Upper Seagry – Commercial

FRA Addendum 3 version 2 (February 2026)

A Flood Risk Assessment (FRA) including a drainage strategy was provided in July 2025 with the planning application for the proposed development of land at Seagry House located off Henn Lane and Startley Road, Upper Seagry, Chippenham, SN15 5HD. The planning application number is PL/2025/06615.

Drainage Strategy
Typical SuDs Details

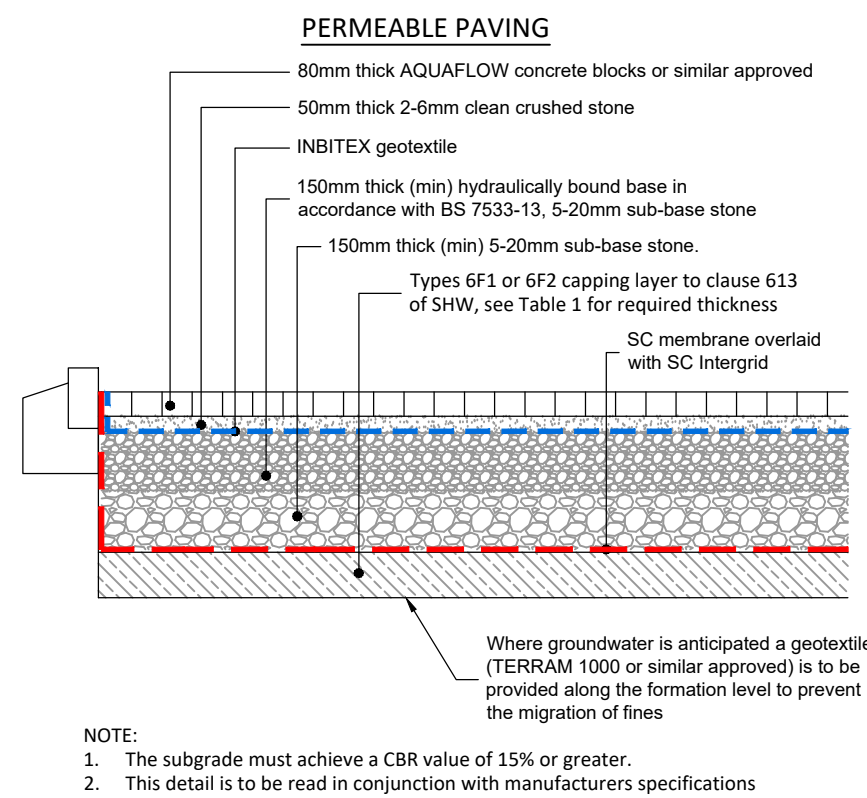
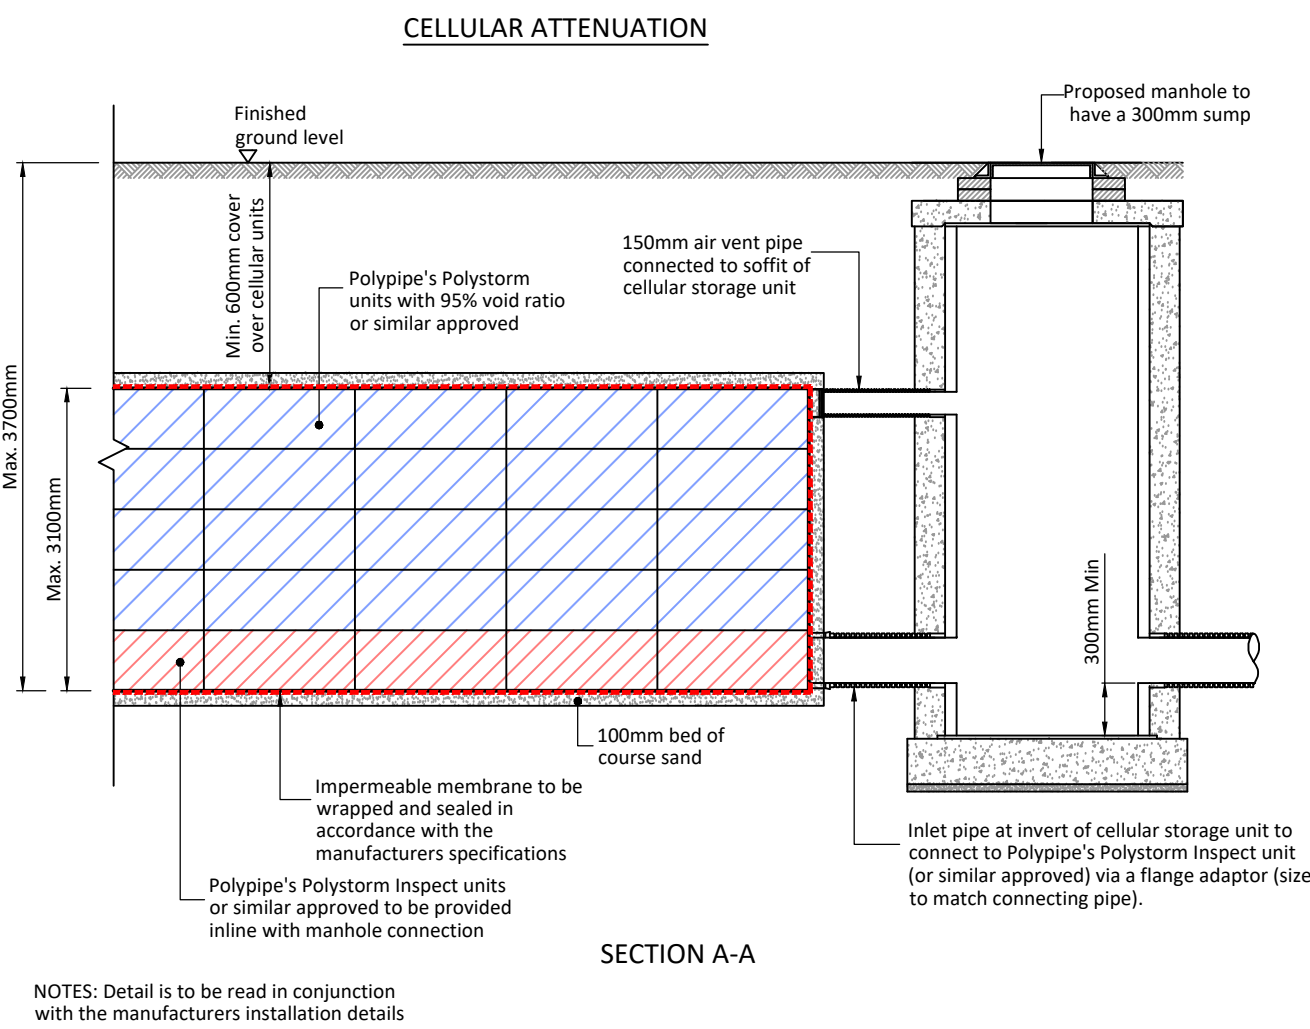
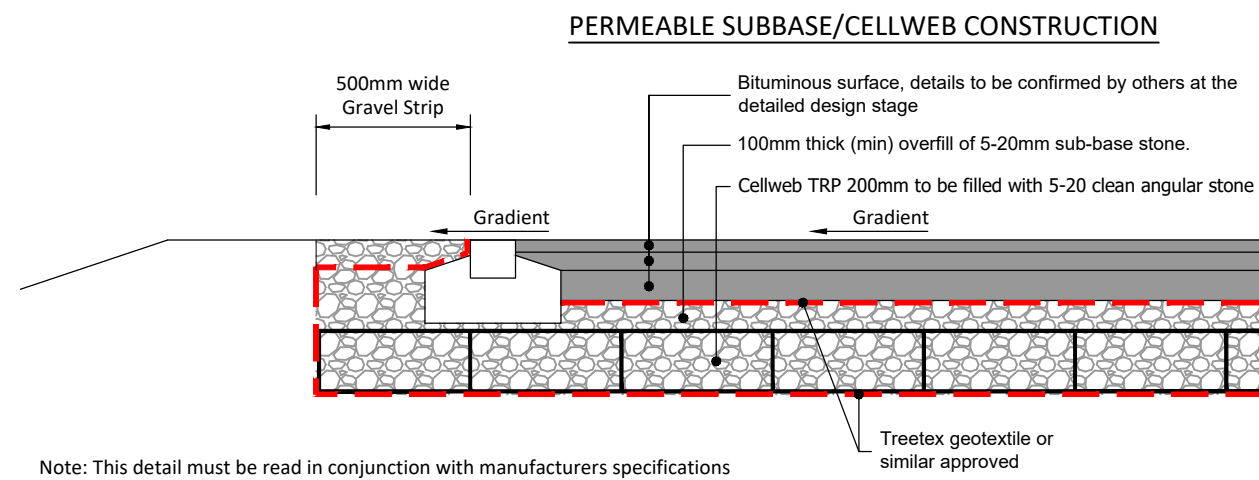
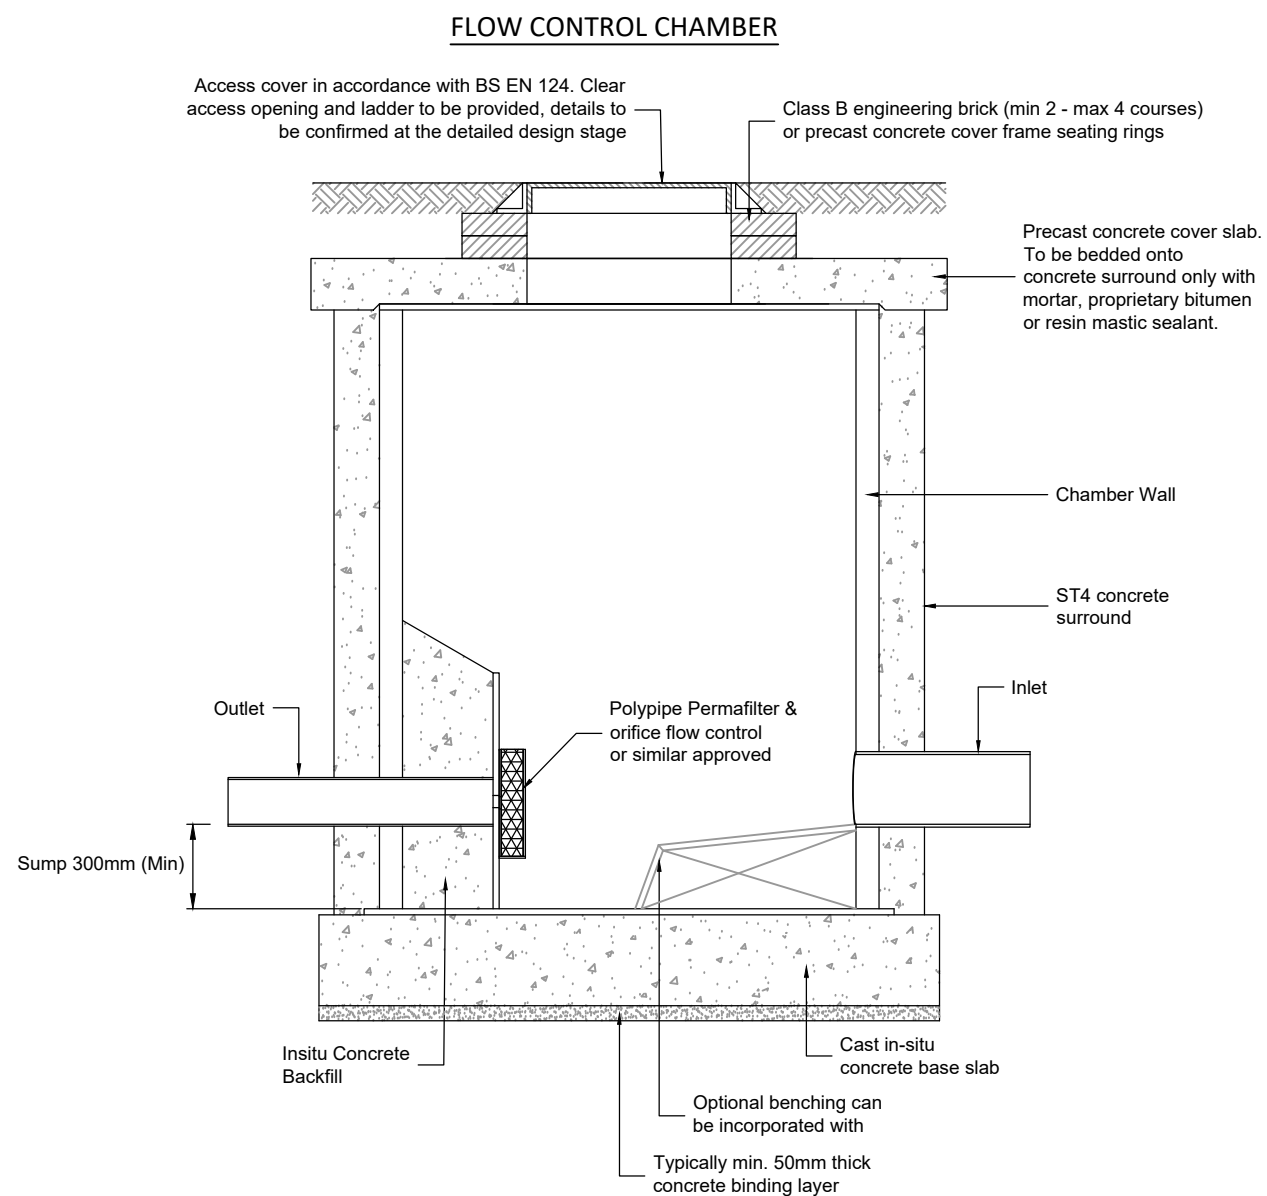
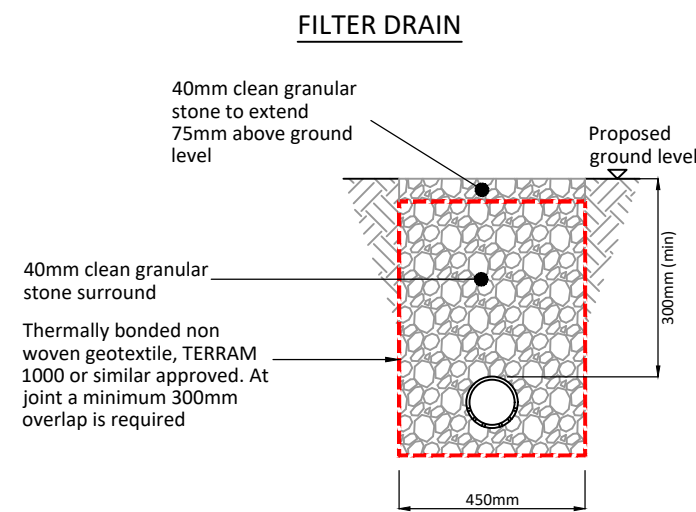
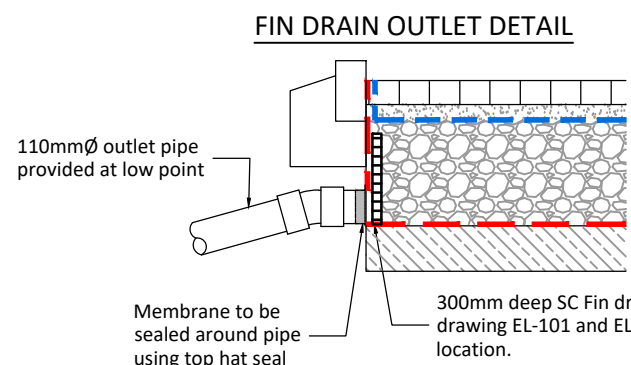
- iii. *The applicant is proposing flow control to be provided through small diameter orifice plates (31mm for the western catchment and 23mm for the eastern catchment). The applicant needs to carry out a blockage risk assessment to demonstrate that these are appropriate. Whilst the SuDS Manual mentions that a 20mm orifice can be acceptable where there is a low risk of blockage, this is generally constrained to closed systems where debris ingress is not possible.*

The drainage design noted that the flow control chamber would be fitted with Polypipe's Permafilter unit or similar approved to reduce the risk of blockage. Also, to add that a large proportion of the surface water runoff would first drain through areas of permeable paving and gravel filter strip, reducing the debris and the risk of blockage. A maintenance and management plan would also be adhered to, as noted in the FRA.

As discussed with the LLFA, we have included typical design details of the proposed unit that is to be included within the flow control chamber on the drainage design provided in **Appendix B**.

C	Flow control chamber added	19/02/26	JH	AC
B	Cellular attenuation detail updated	14/10/25	JH	AC
A	First issue	17/07/25	JH	AC
REV.	DESCRIPTION	Date	BY	CHK

Site location Plan (Included blue line ownership extent)

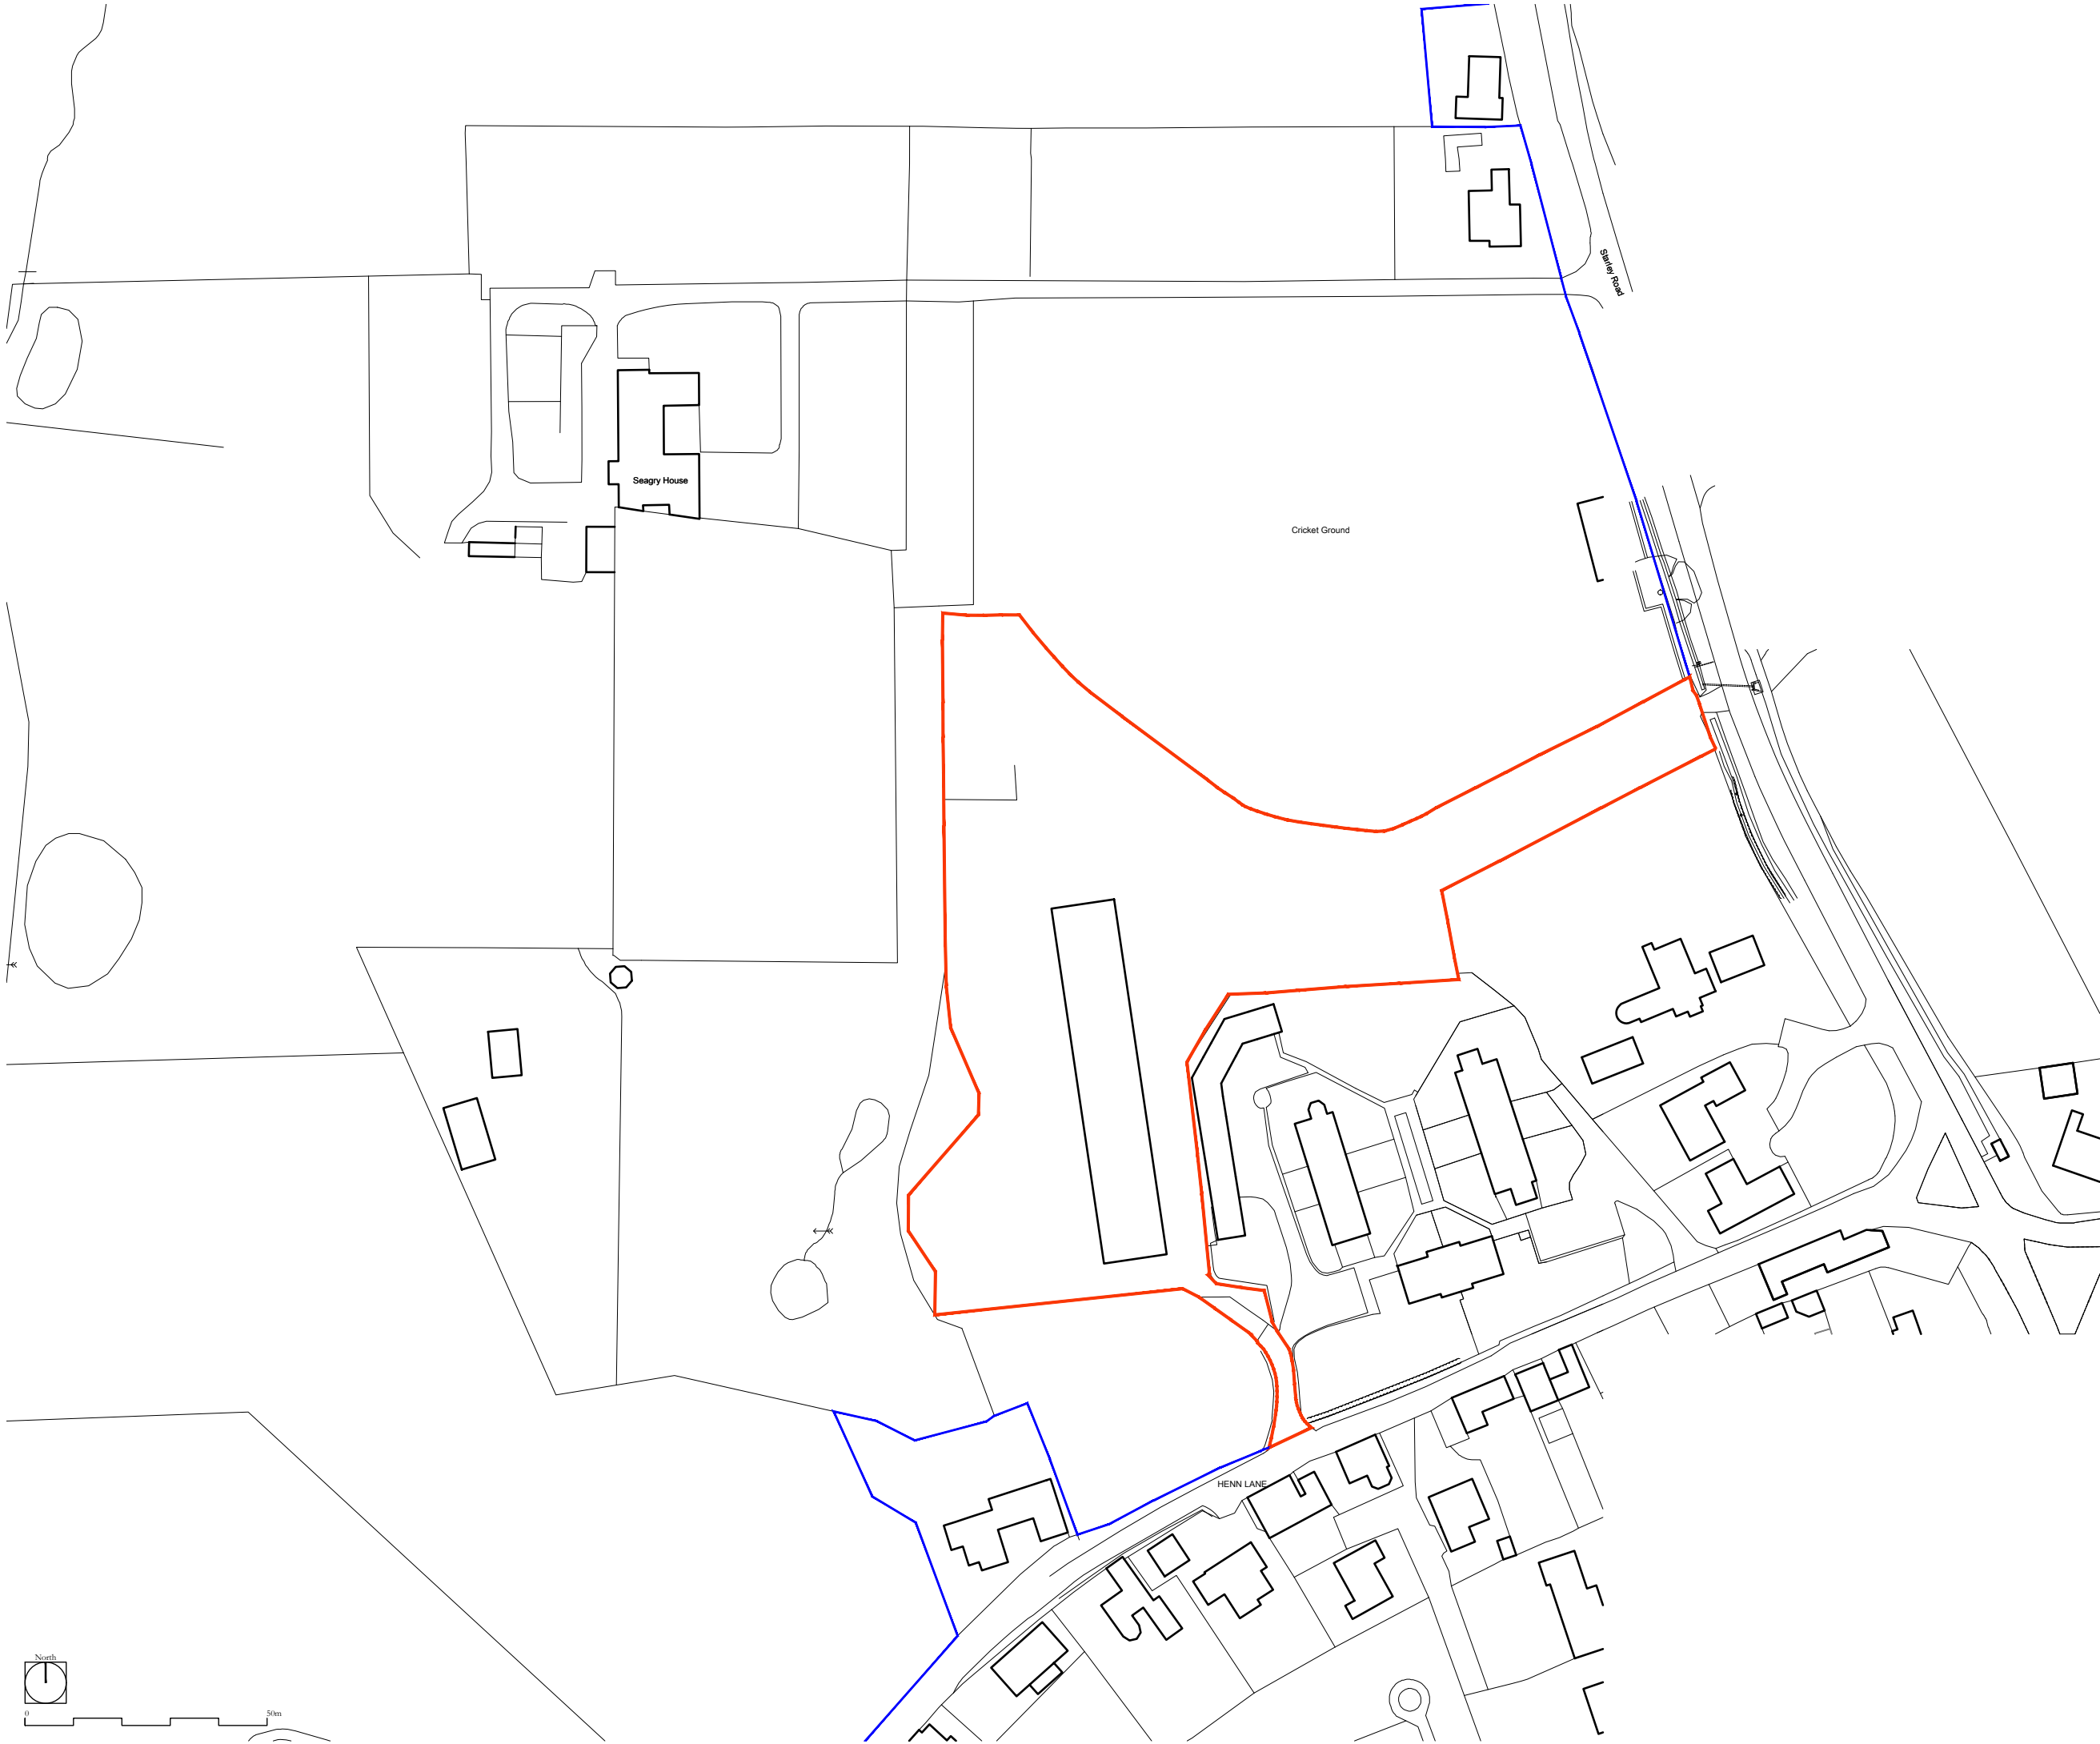
With regards the western catchment, the current connection to private surface water sewer is stated to be within the applicant's land but is shown to be outside of the application red line boundary. We would expect the applicant to confirm the location of the connection point at this stage, and either demonstrate this is within their own land ownership or provide agreement from the relevant landowner and asset owner.

The blue line site boundary extends far beyond the site to the north and west, see site location plan as **Appendix E**. This showing that the proposed connection point is within the land ownership extent.
